Staff Report

Re: PLCCPM2016-00997 Pierpont Apartments

Conditional Building & Site Design Review

1 NORTH ELEVATION
 SCALE: 1/8" = 1'-0"

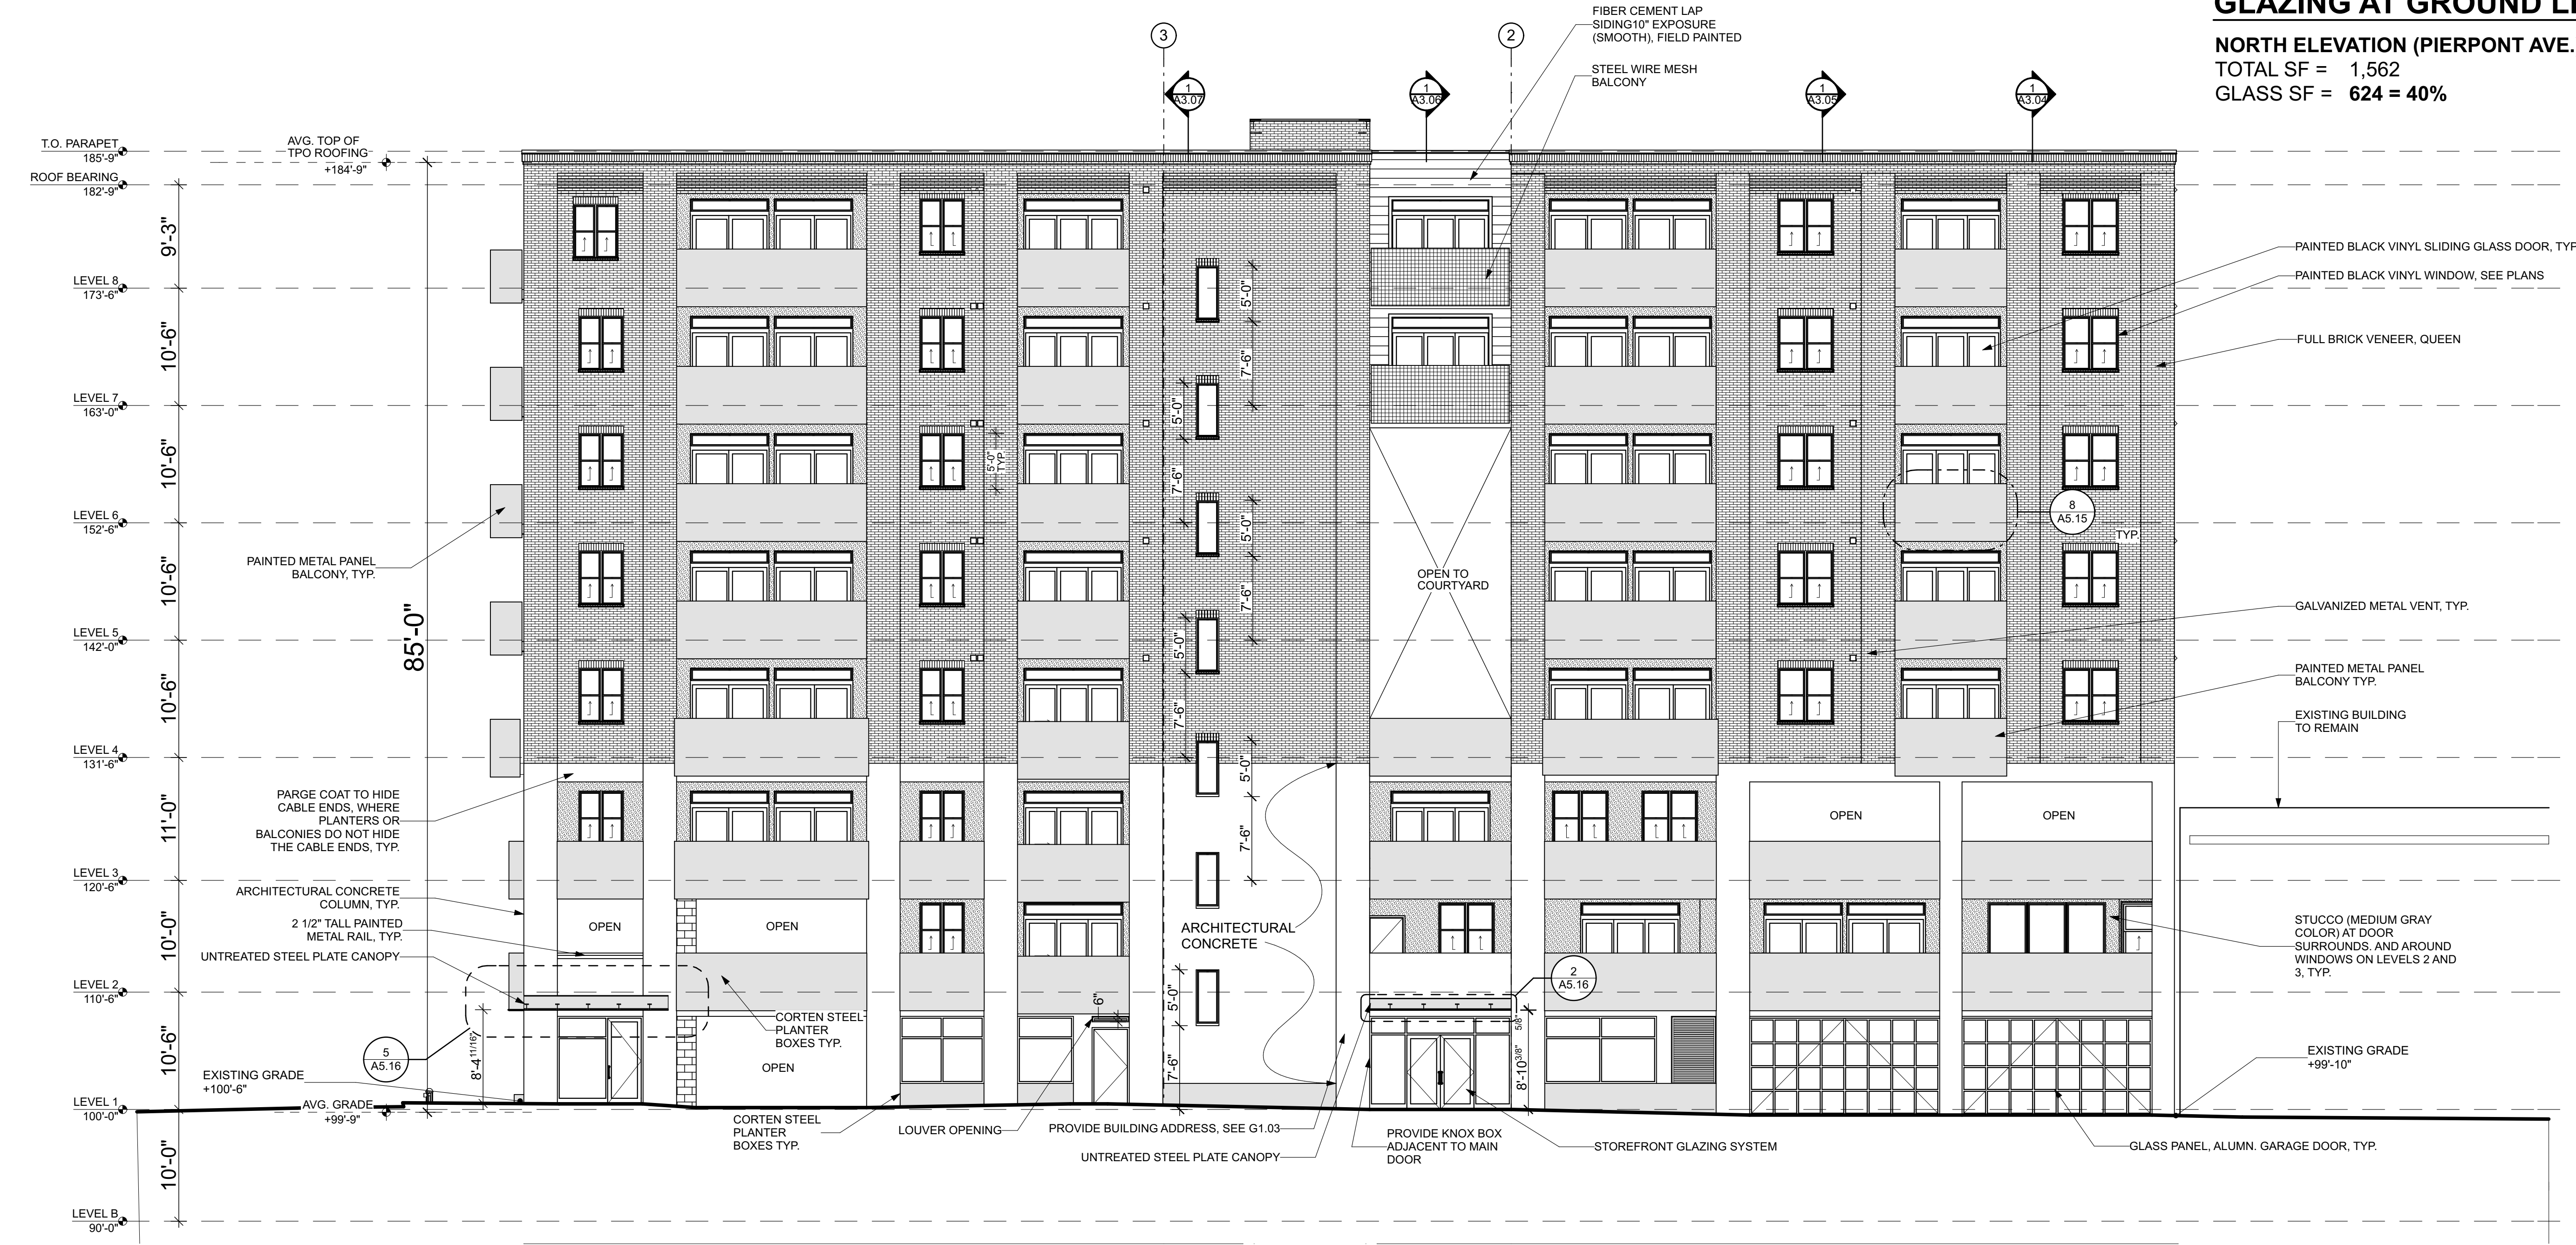
Additionally, in the north side of the building above the main entrance on levels 4-6, there is a total opening in the façade which measures approximately 30 feet by 13 feet and accommodates air flow and views from the common tenant space on the fourth floor outward to the north and downward to Pierpont Avenue. The tenant plaza is completely open to the sky with the exception of floors 7 and 8 above the opening in the northern façade where two units are located. They serve to break up the mass of the structure even more by being stepped in even further than the other 20 inch recesses on those levels to accentuate the opening directly below them.

NORTH ELEVATION (PIERPONT AVE.)
 TOTAL SF = 1,562
 GLASS SF = 624 = 40%

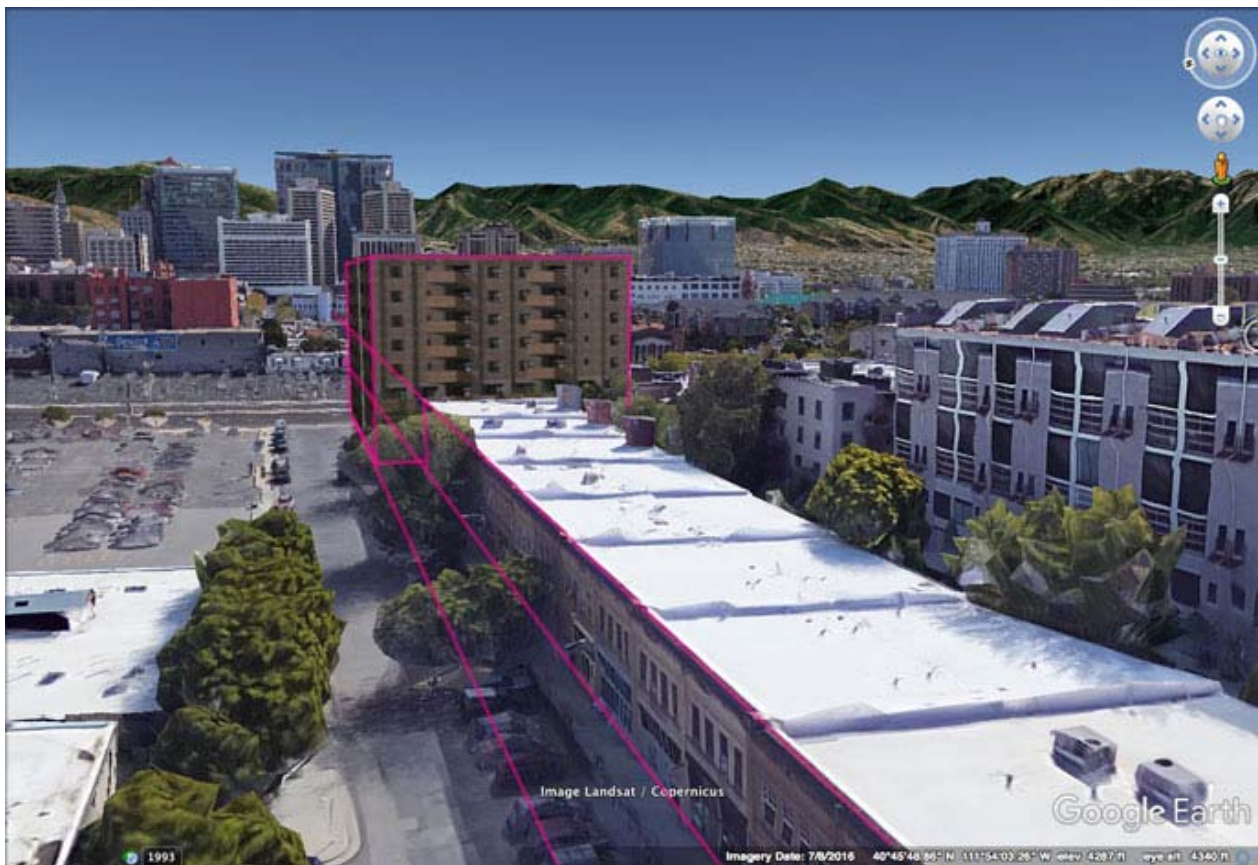
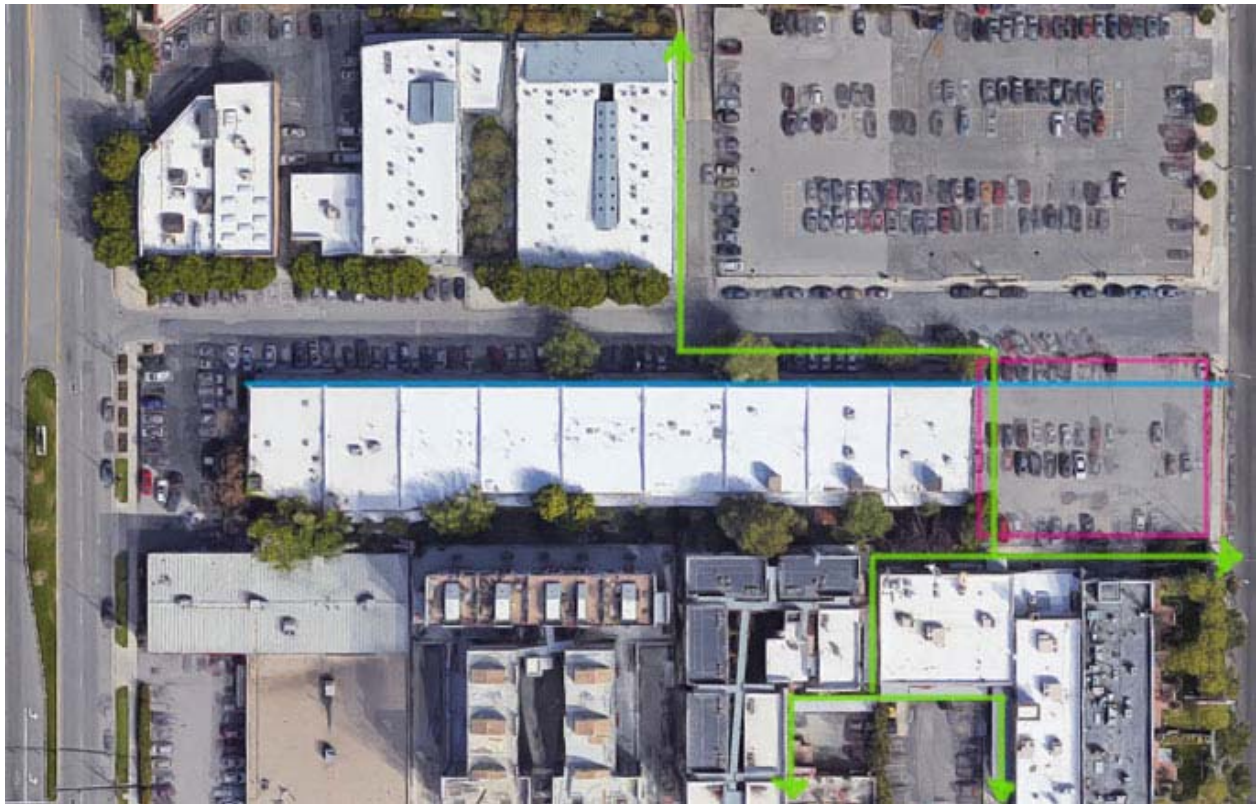
2- Height: I don't believe the Pierpont Apartments should be noticeably taller than the Crane Building. The historic Crane building is the tallest original structure on the block. It commands a strong presence due to its height. Like Artspace, Crane is a significant character-defining landmark, lending great authenticity to the Warehouse national historic district. Even at the originally proposed 75 feet, the Pierpont Apartments would dwarf the Tire Town building and the Artspace building. If the additional height is to allow for above-grade parking, extreme scrutiny should be used when determining if the height is appropriate.

Example: Broadway Park Lofts (BPL) on the same block at 360 west Broadway was granted additional height only for the small structures that house staircases leading to roof patios. While the total height is around 85 feet, the *perceived* height is 75' because the penthouse roof structures are minimal and set back:

A comment (see Attachment H) was received suggesting that the proposed structure should not be higher than the Crane Building which is located north of the subject parcel at the corner of 200 S and 300 W. The email also stated that the Broadway Park Lofts which are southwest of the subject parcel (midblock on 300 S between 300 W and 400 W) only extends up to 85 feet for structures in the middle of the roofs that house stairways up to rooftop balconies and that this building should be similar in that regard. The crane building is only 5 stories tall and likely around 55 feet in height. With the base zoning allowing buildings to be up to 75 feet in height by right, and up to 90 feet through the conditional building and site design process, such a parity is simply impossible. Moving into the future structures will be much taller than the crane building as Salt Lake becomes a more fully developed and dense city. Similarly, while the Broadway Park Lofts building is 85 feet in only certain sections of the building, it does reach the same height as proposed for this project. The proposed building will interface well with it and serve as a visual balance to the existing structure.
